Question Number	Topics or Referenced Document	Date of Question	Date Replied	Question	Response
1	CCDC 2 - 2020 RFP Package – HFI Lab Construction – IFB rev0	April 6, 2026	April 20, 2026	6.3 Payment Terms: Prompt Payment - The proposed 45-day payment timeline is in contravention with the prompt payment requirements of the Ontario Construction Act.	HFI will follow the Canadian Construction Documents Committee (CCDC 2 - 2020). As per section 5.3.1.2 <i>“Payment will be on or before 28 calendar days after the receipt by the Owner and the Consultant of the application for payment, and in any event, in compliance with Payment Legislation.”</i>
2	RFP Package – HFI Lab Construction – IFB rev0	April 6, 2026	April 20, 2026	6.3 Payment Terms: Please confirm that the proposed retainage is separate from the statutory holdback required by the Ontario Construction Act.	There will be no separate retainage outside of the statutory holdback. Monthly progress payments will be based on certified completed work, retaining a 10% statutory holdback on each payment in accordance with the Ontario Construction Act. The holdback retained for the Work shall be released 45 days after the date the Certificate of

Figure 3 - Drawing E2 Excerpt

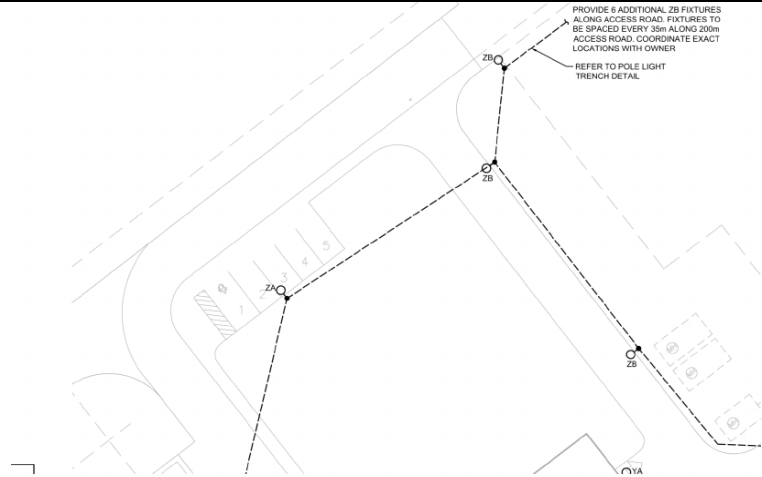
INCLUDE FLEXIBLE RUBBER HIGH TEMP COUPLING AT EQUIPMENT."
 <p>Figure 1 - M7 Note 12</p>					
10	E2 / C3	April 9, 2026	April 23, 2026	E2 has a description for site lighting. Drawing C3 shows the light fixtures and they are spaced from 43m to 63 m Road length is 350 m so you would need around 11	Spacing to be 35m. Currently 2 shown in parking area and 6 along roadway to the east of lab building. Adding an additional 3 along roadway to the west of lab building. Addendum to follow.
 <p>Figure 2 – Drawings 2 Excerpt</p>					
11	E3	April 9, 2026	April 23, 2026	Drawing E3 does not show lighting to the west of the site.	Spacing to be 35m. Currently 2 shown in parking area and 6 along roadway to the east of lab building. Adding an additional 3 along

roadway to the west of lab building.
Addendum to follow.

Figure 4 - a) dimensions requested at the paved ditch area

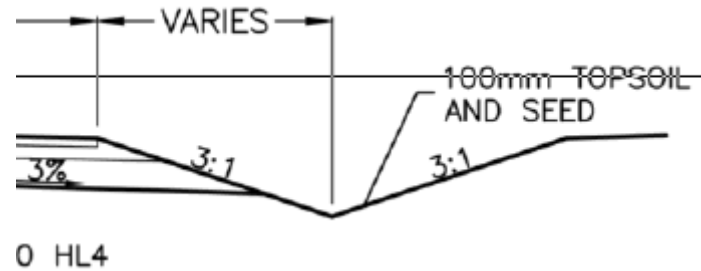
It's not clear but for topsoil and seeding can you please supply the following

- a) Can you please get us dimensions at the paved ditch area, both sides
- b) Extent around the building, does it cover grading area note 13 & 18 on A020

Figure 7 – Drawing C3 Excerpt

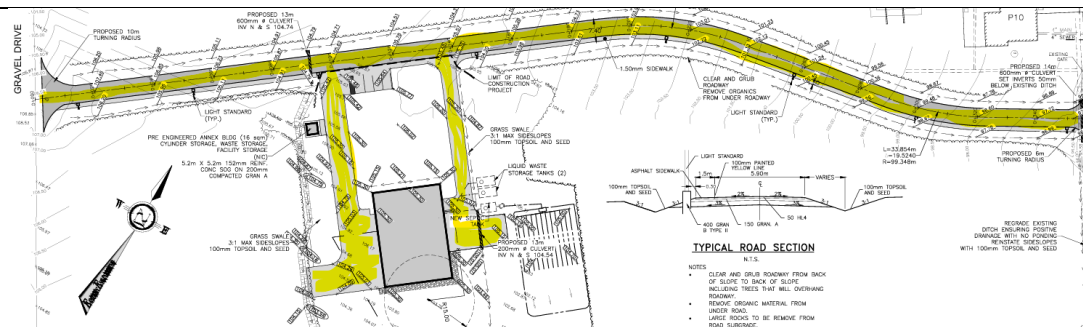
30	C3	April 15, 2026	April 20, 2026	Architectural drawings indicate that the main access road is not included in this contract and will be completed by others. Can you please delineate the limit of the scope of work on the civil drawings for what we are to include in this contract?	The new main access road, "service road" will be included in this contract and bids should reflect that. On C3, all roads shown are part of this contract. Provided below is a screenshot of drawing C3 with roads to be built highlighted in yellow.
